**Our Case Number: ABP-316828-23**

**Re:** Tallaght/Clondalkin to City Centre BusConnect Core Bus Corridor Scheme.  
Tallaght/Clondalkin to Dublin City.

# South Dublin County Council Submission on Bus Connects

Tallaght/Clondalkin to City Centre Core Bus  
Corridor Scheme.

**Proposed Compound location TC6**

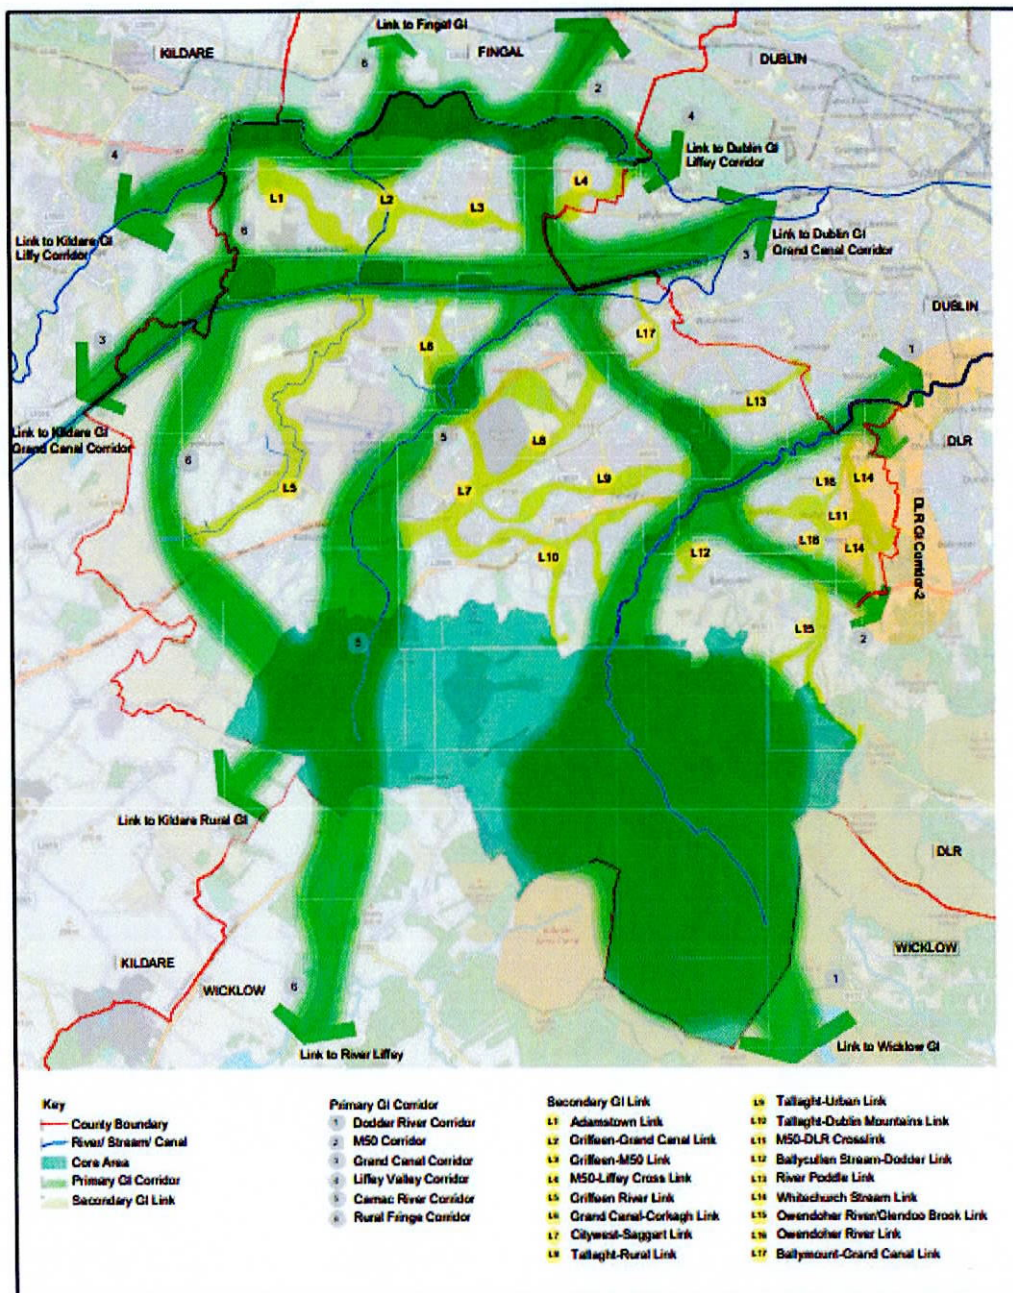
- Location within Tymon Park: SDCC recommend locating elsewhere. If ABP do not agree, protection of existing habitats, reinstatement and landscape compensatory measures are to be agreed with SDCC Public Realm Section prior to commencement of any works.

**Tymon Park: Drawing No.: CIDE-JAC-ENV\_BD-0809\_XX\_00-DR-GG-0403**  
 Open space both sides of road, no bat transects at this location.

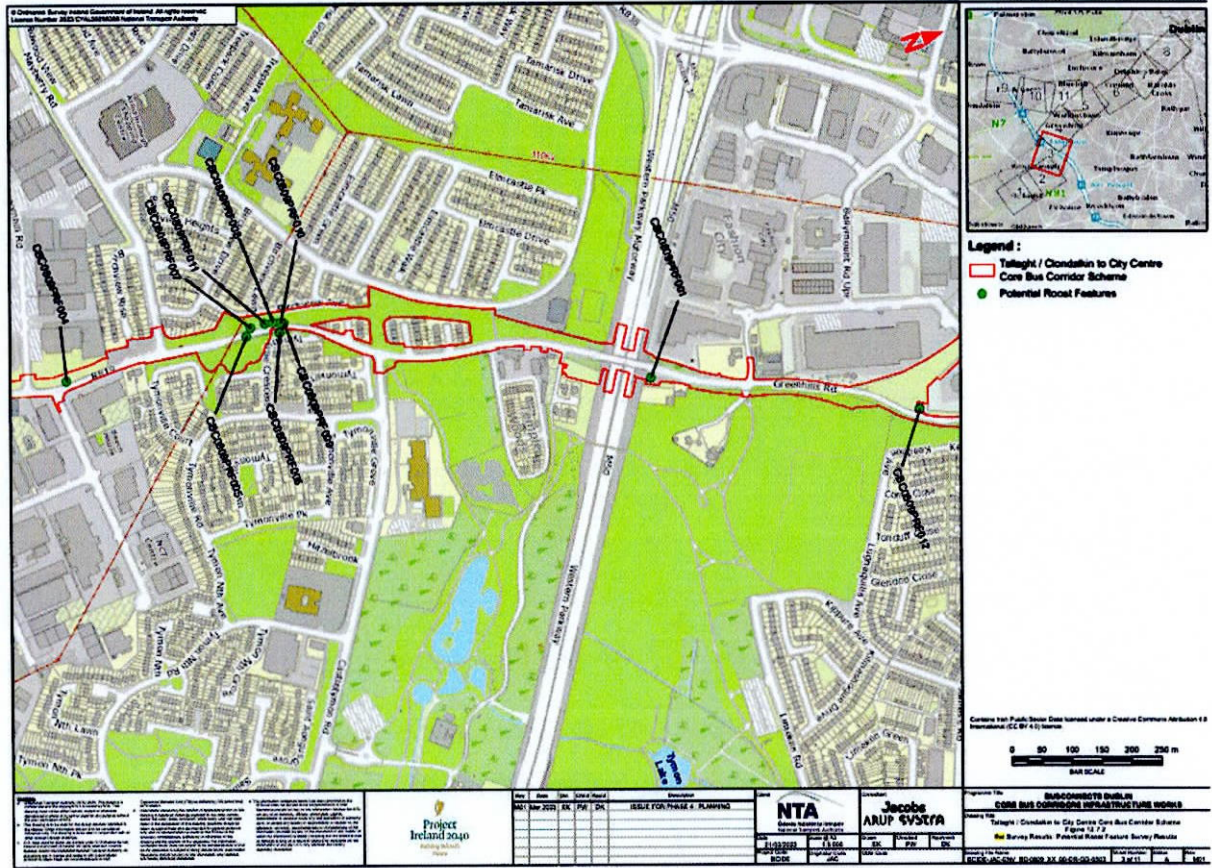
We note with concern the lack of bat survey transects for a significant portion of the proposed route between Bancroft Park and Tymon Park; see Drawing CIDE-JAC-ENV\_BD-0809\_XX\_00-DR-GG-0403 below. Tymon Park is part of the significant ecological corridor in the county that is a named Green infrastructure Strategic Corridor.. It represents a significant ecological corridor that runs north south through the county. One can see from the map below the significant corridor of green space that runs north south at this location. One would expect bat surveys to be carried out to ensure the EIAR properly assesses the impact of the scheme. The omission of bat survey work in this area, given the significant proposed changes to the open space areas in this locality raises concerns about the assessment of impacts on biodiversity.

- The applicant is requested to carry out further bat survey work along the proposed route between Bancroft Park and Tymon Park, in discussion with SDCC and assess the findings against the proposals.

**Bancroft Park: Drawing No: BCIDE-JAC-ENV\_BD-0809\_XX\_00-DR-GG-0402**

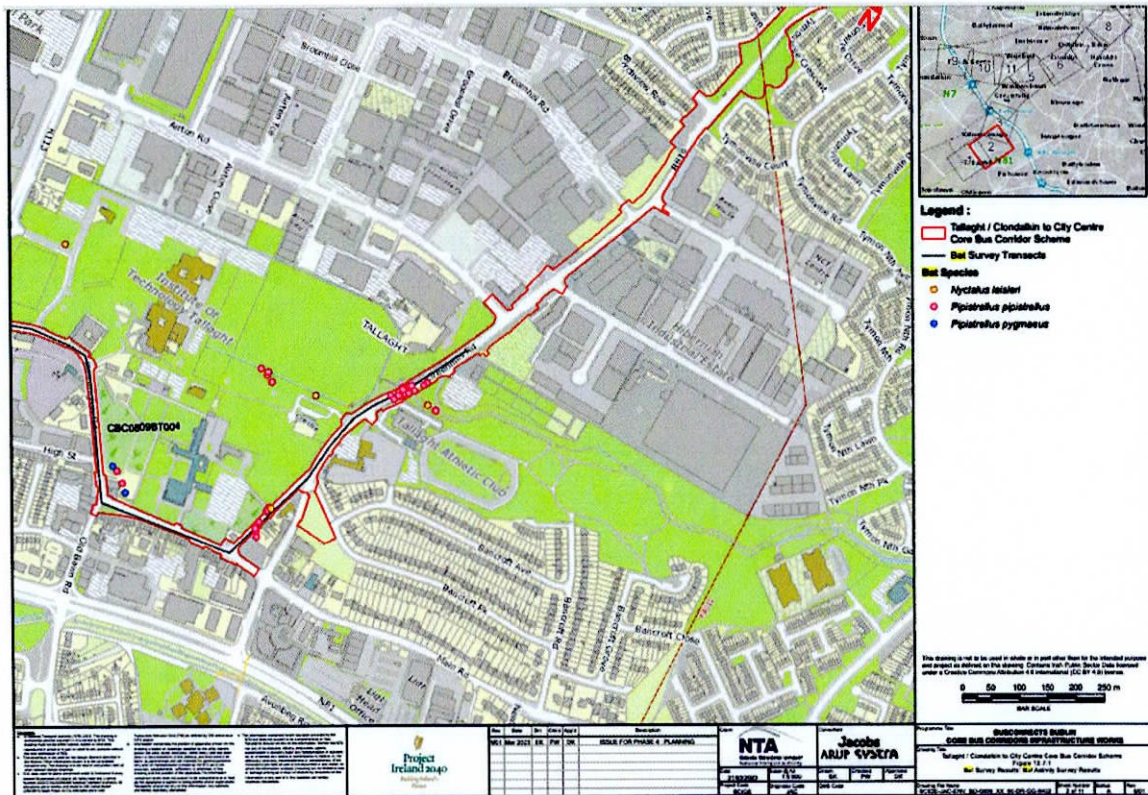
Given the identification of potential bat roosts by the project team within this area of Tymon Park makes the lack of bat survey transects all the more puzzling. (See potential roost location drawing below BCIDE-JAC-ENV\_BD-0809\_XX\_00-DR-GG-0503)

**Grand Canal Location: Drawing No. BCIDE-JAC-ENV\_BD-0809\_XX\_00-DR-GG-0409**

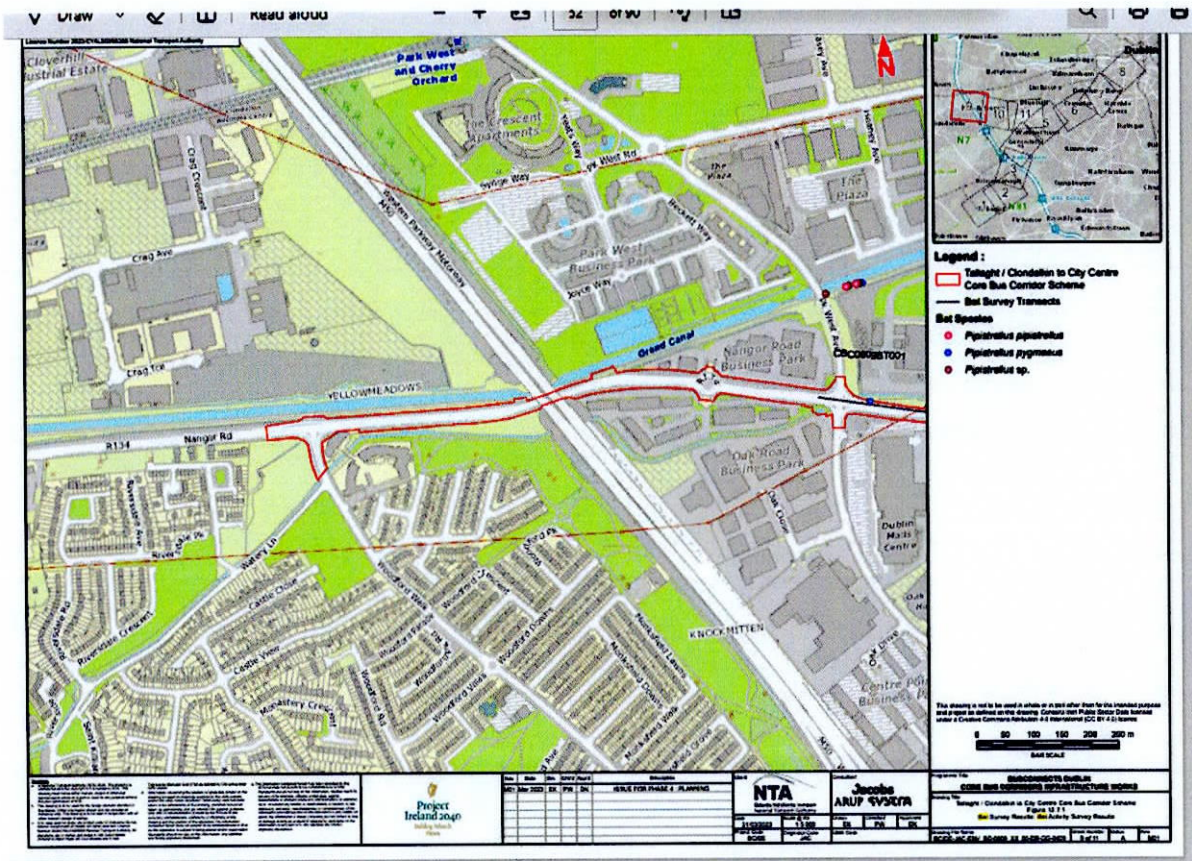
Similarly concerning; there are no bat survey transects recorded where the development is adjacent to the Grand Canal (see bat survey location drawing below)

SDCC would expect, given the proximity of the site at this location to the pNHA at the Grand Canal, and the linear nature of the Grand Canal ecological corridor (A Green Infrastructure Core Area in the SDCC County Development Plan) that is of national importance -connecting Shannon River to Dublin Bay Biosphere- that the applicants would have chosen this location as one of the locations to survey for bats, to ensure potential impacts are properly assessed.

- The applicant is requested to carry out further bat survey work at the location of the proposals adjacent to the Grand Canal pNHA in discussions with SDCC and assess the findings against the proposals.

**General Arrangement Drawing: BCIDA-ACM-GEO\_GA-0809\_XX\_00-DR-CR-9001**

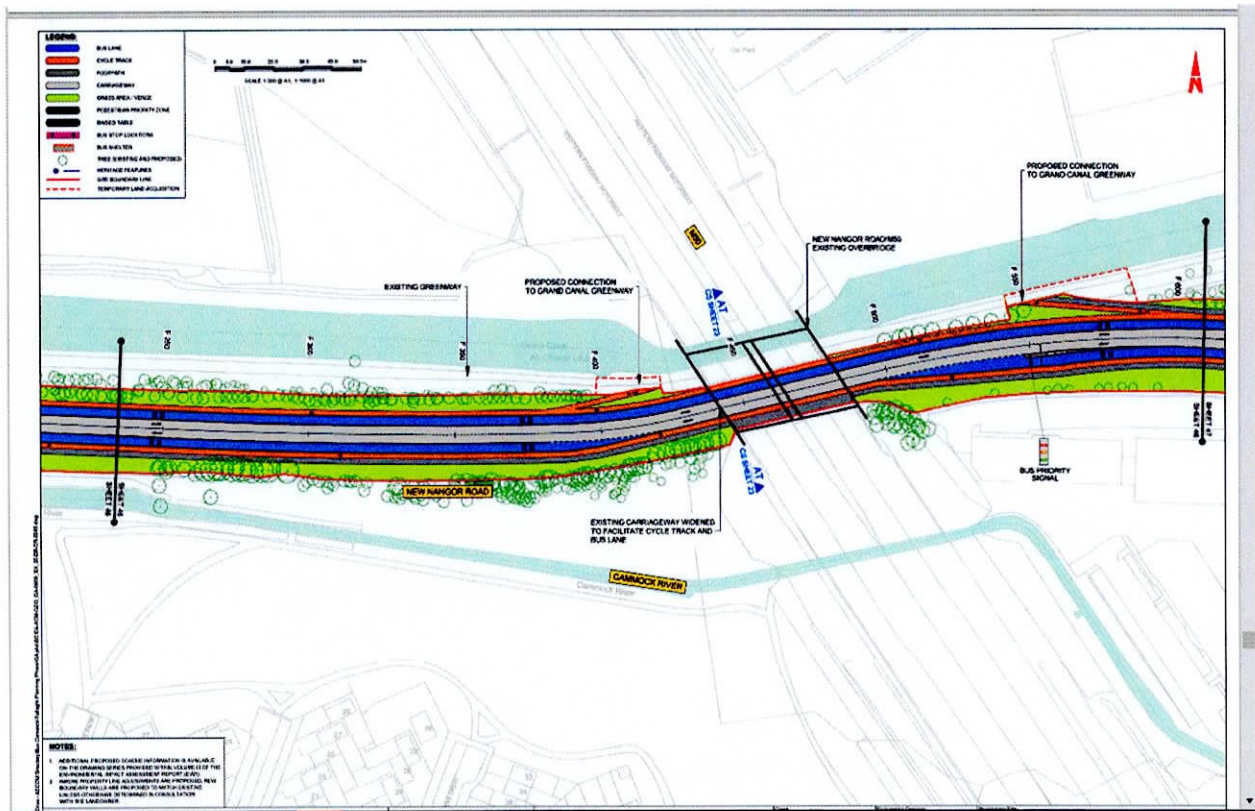
Regarding the above surveys marked Aquatic and Riparian Survey Sites, given the importance of the Grand Canal as an ecological corridor otter and kingfisher surveys along its length should be carried out where the scheme runs adjacent to it and the sparsity of aquatic and riparian survey carried out. Added to the lack of bat transects in the area, it seems a significant omission. There are proposals to carry out works within the buffer zone of the pNHA and even within the pNHA area itself. See general arrangement drawing below:

Figure 5

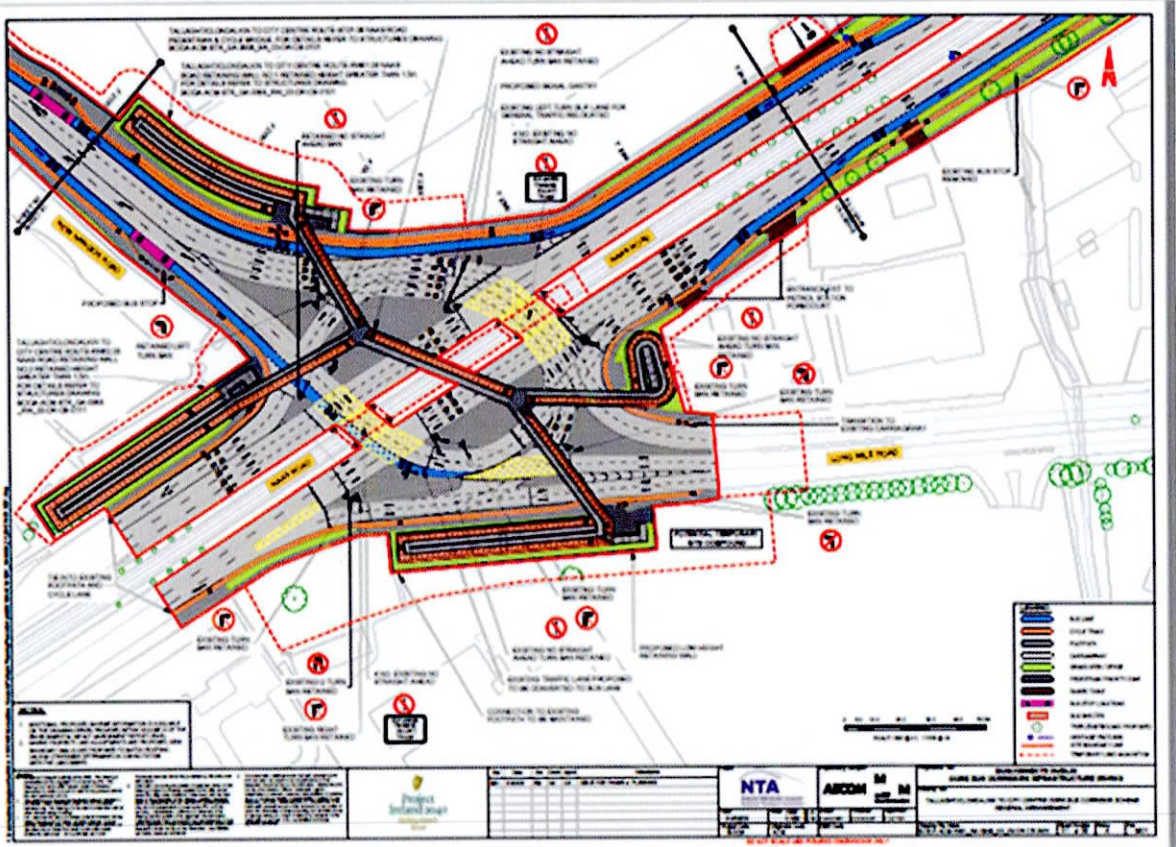
South Dublin requests a revisit of the design of the proposed cycle bridge at the intersection of New Nangor Road, Naas Road and Long Mile Road (the ‘Hamburger’ Junction). This junction is a highly visible location, and the functional design of the proposed bridge is a missed opportunity to create a landmark structure that would be a visual focal point for the emerging City Edge area. There is potential for the bridge to be a gateway structure that sets a design standard for the City Edge area. The bridge should create a strong visual impact, contribute to the place making of the area, create safe linkages between the two areas of the Naas Road and allow for efficient access across the Long Mile Road. SDCC acknowledge the important function of the bridge and welcome the inclusion, however, the current design responds to the current context and does not acknowledge the City Edge Strategic Framework context. SDCC request further consideration of the design and visual appearance of the bridge through condition with finishes, lighting and design to be agreed.

In the event of a grant of planning permission, a condition should be applied seeking the detailed design and materials for the proposed bridge and approaches should be agreed with the local planning authority.

Figure 6

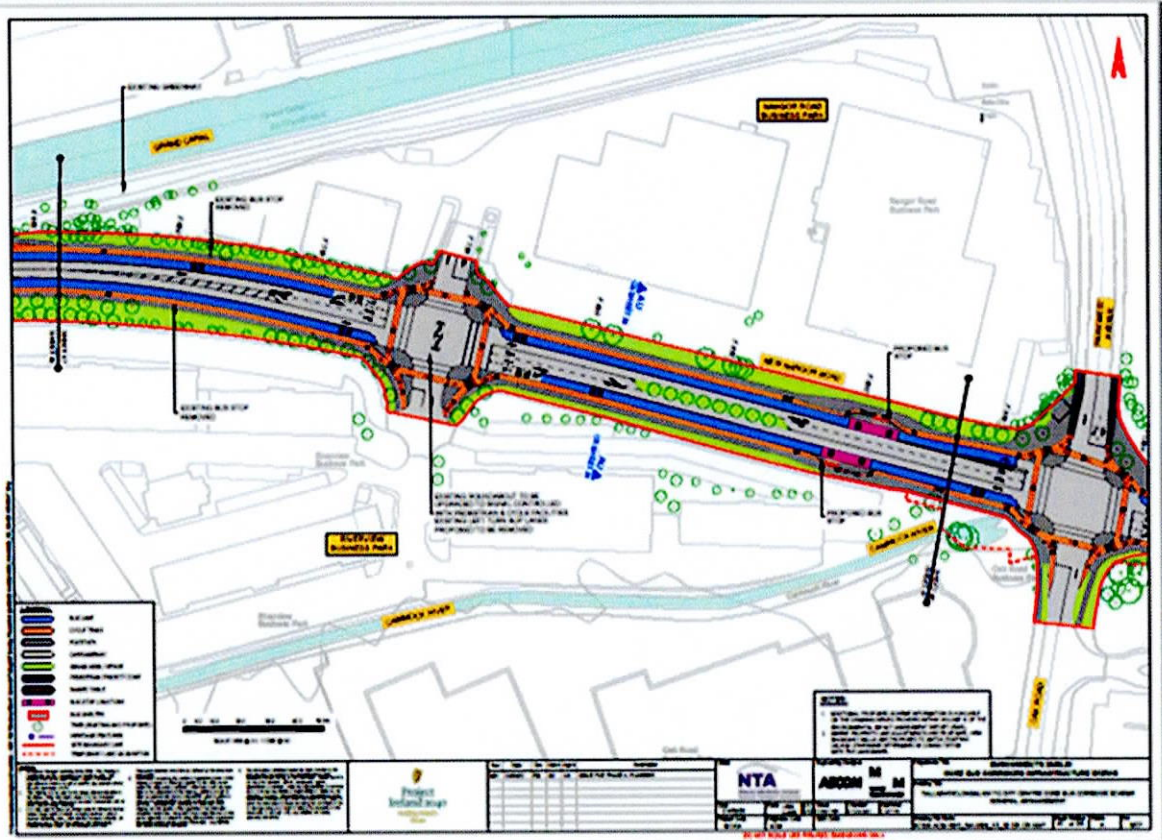
Oak Road forms part of a proposed north-south ‘outer orbital’ public transport route in the City Edge Strategic Framework. It should be noted in the design of this junction/route that it will require to be capable of taking more extensive traffic in the future.

Figure 7

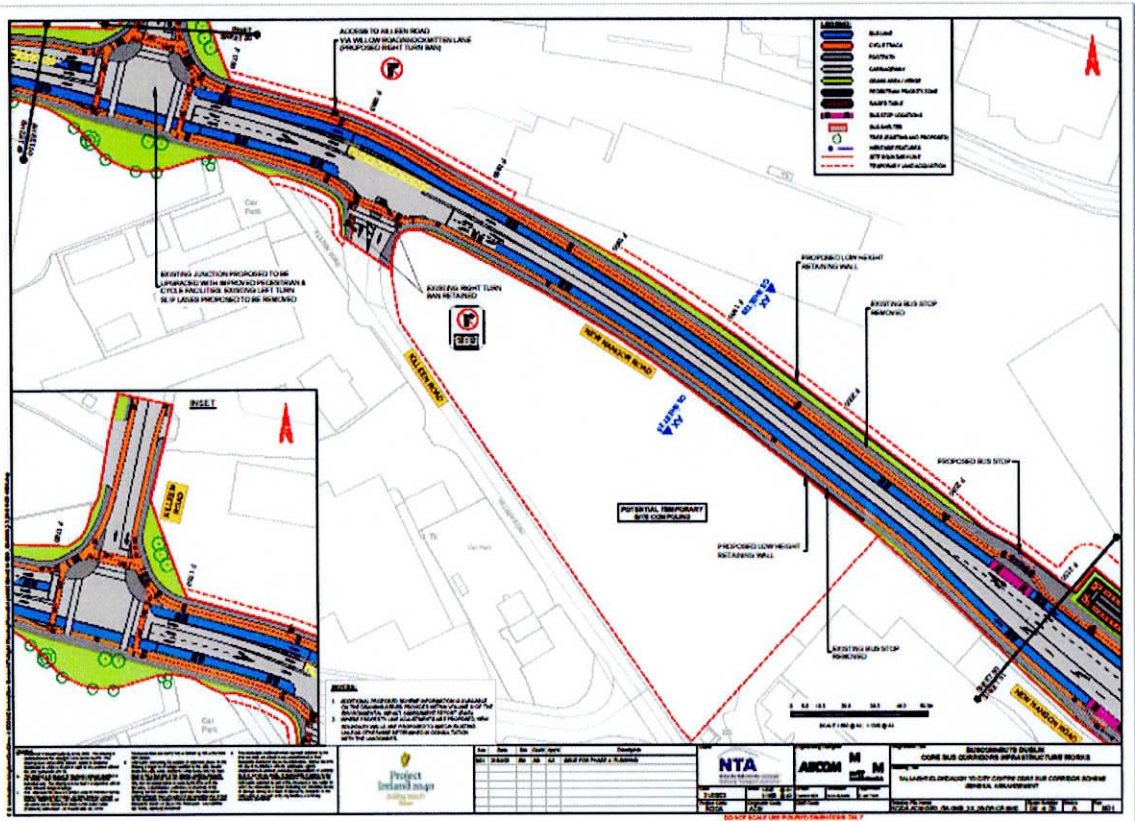
The design as proposed is hard in appearance. More greening is encouraged along the Nangor Road to soften this visually.

Figure 8

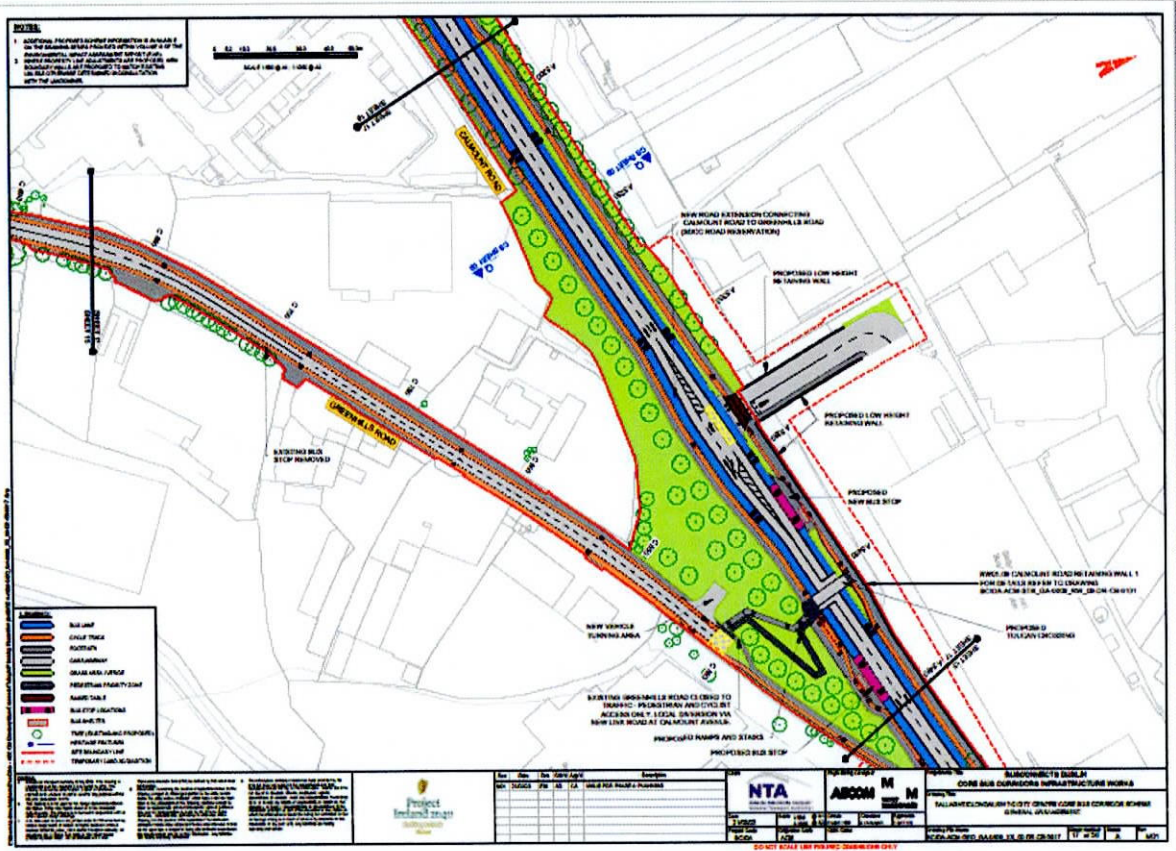
The proposal to route the Core Bus Corridor along Calmount Road is welcome in the context of this being identified as a future local high street within the City Edge Strategic Framework. However, SDCC would encourage the provision of more greening and SUDS within the design. As well as revisiting the specification for the connection to enhance outcomes. Please also note comments previously set out in the traffic sections. In the event of a grant of planning permission the detail design and layout of this green space at the junction of Calmount Road and Greenhills Road should be agreed with the local authority to address detailed concerns over the active travel access between both roads and the quality of the green open space and its maintenance into the future.
